- A. Over-Rich Running - Mariner/Mercury 60 (3 Cyl.)
- B. Vent Screw - Fuel Tank Cap - Mercury 2.2 and 4
- C. Warning Horn Sounding a Low Tone - Mercury 35 and Mariner/Mercury 45-60 and 115 Electric Start Models

**A. OVER-RICH RUNNING - MARINER/MERCURY 60 (3 CYL.)**

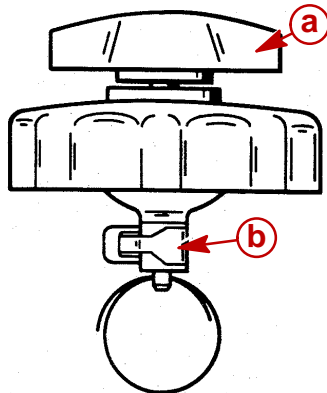
The 60 HP outboards identified below have a .0785" main fuel jet in the TOP carburetor. If the owner/operator complains of an over-rich running condition (four cycling, blubbering, etc.) ABOVE 4500 RPM, remove the .0785" main fuel jet and install a .074" main fuel jet P/N 1399-3794.

The bottom carburetor has a .072" main fuel jet which should not be changed.

**Figure 1. Fuel Tank Cap**

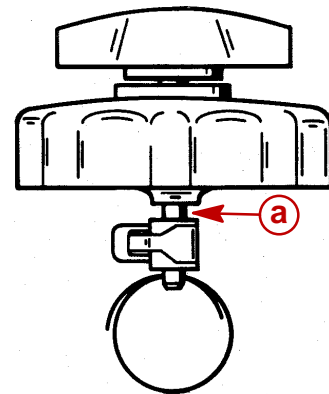
We have received a few reports that the fuel cap vent screw does not operate **correctly**. **Turning** the vent screw (Figure 1) is limited to 1/4 or 1/2 turn. When released, it returns (snaps back) to the original position. This usually occurs the first time the fuel tank is attempted to be vented.

1. Remove fuel tank cap from fuel tank.
2. Inspect the position of the metal clamp (Figure 1). The bottom of the metal clamp must be even with or very close to the bottom of the sealing rubber. Reposition the metal clamp if necessary.
3. With a sharp knife, cut through the sealing rubber to the screw shaft just above the metal clamp and separate (Figure 2). Do not remove the metal clamp and the rubber piece thee it holds.
4. Re-install the fuel tank cap.

**Figure 3. Quicksilver 2000 Remote Control**

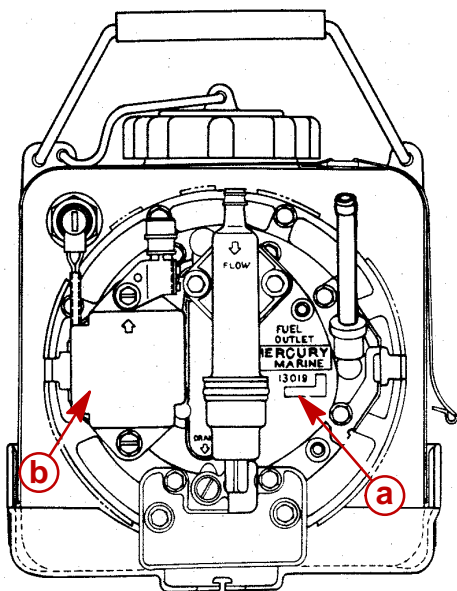
Warning horn sounding a low tone when the engine is running may be caused by electrical RFI (radio frequency interference) from the engine. This only occurs when the Quicksilver 2000 remote control (Figure 3) with the warning horn inside is used with the P/N 13019--4 AutoBlend. Although all 1988 Mercury 35 and Mariner/Mercury 45,50,60 and 115 electric start models are shipped with this series remote control and AutoBlend, we have received only a few complaints.

**Figure 4. AutoBlend 13019--4**

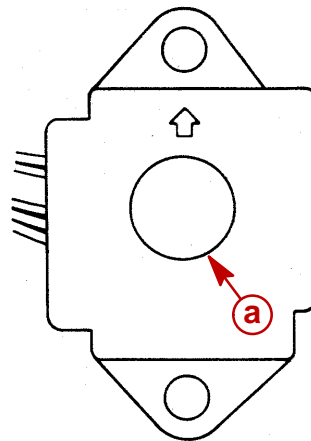
An improved AutoBlend electronic module (P/N 19264) that eliminates the affect of RFI has been installed on AutoBlends midway through the manufacture of lot #BJ (Figure 4). To identify the improved module, a round green sticker (Figure 5) has been applied to the module case.

Replace warning module on 13019--4 AutoBlends with latest warning module (P/N 19265) if all of the items apply:

1. Warning horn sounds a low tone only when engine is running.
2. Remote control is a Quicksilver 2000.
3. Lot number is BJ or previous, i.e.: BI, BH, BG, etc.
4. Warning module does not have a round green sticker
5. Warning module does not have a letter "M" molded into the case.

**Figure 5. AutoBlend Module P/N 19264**

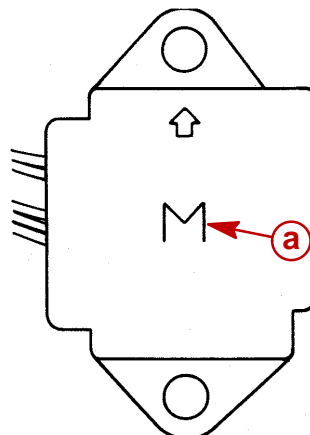
A further improved module (P/N 19265) will be installed on AutoBlends starting with foe code CA and can be identified by a letter "M" molded into the module case (Figure 6).
